TOWN OF AJAX

COMMITTEE OF ADJUSTMENT

SUBJECT: **Minor Variance Application A7/15**
Windcorp Grand Harwood Place Ltd.
184 Harwood Avenue South
(Part 1, 40R-28209)

REFERENCE: Site Plan Application SP2/14

Figure 4

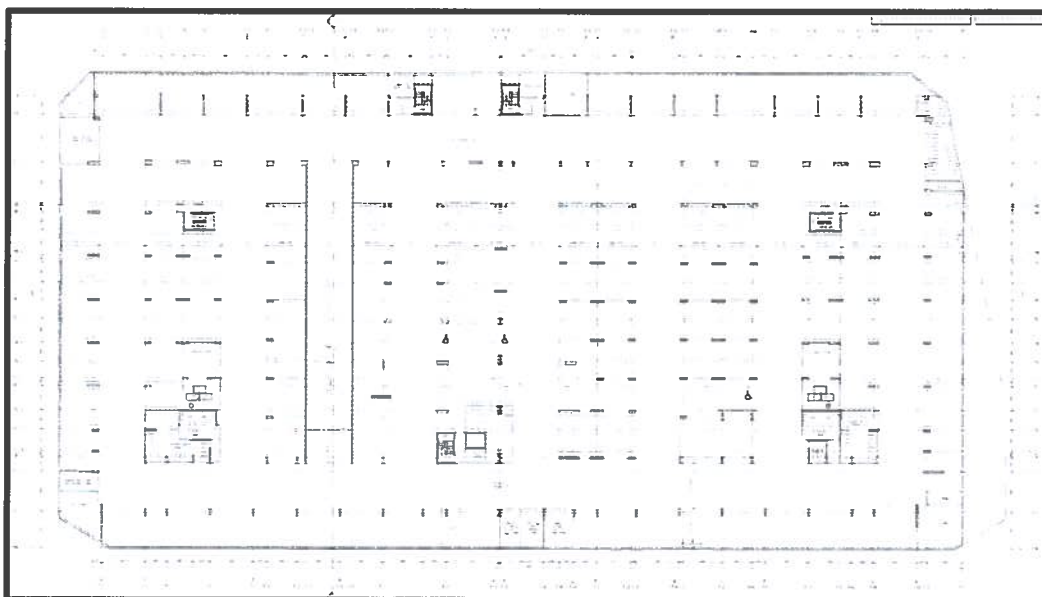
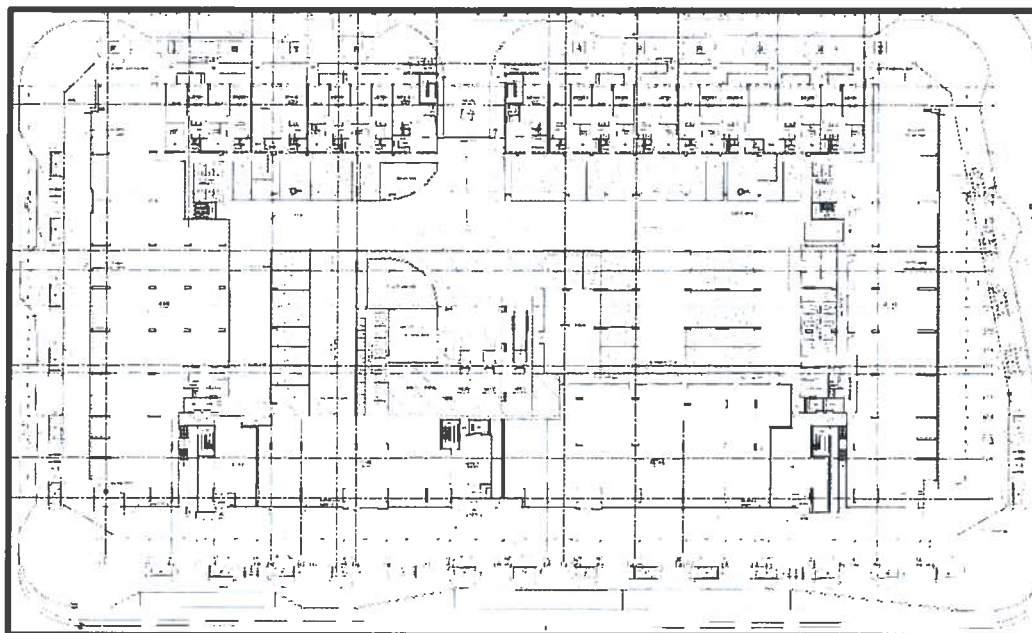
Table 2 indicates that a total of 163 parking spaces would be required for the amount of floor space proposed for office and retail uses. The proposal would permit a blended parking requirement of 154 parking spaces for all non-residential uses, in order to allow for the sharing of parking spaces at different times of the day or week. Parking related to the office and retail uses will be located on the ground floor level and the P1 level of the underground garage. Figure 4 shows the layout of the ground floor and P1 levels.

In staff's view, the proposed minimum of 154 parking spaces for office and retail uses meets the general intent and purpose of the Official Plan and Zoning By-law and is desirable for the appropriate development of the land.
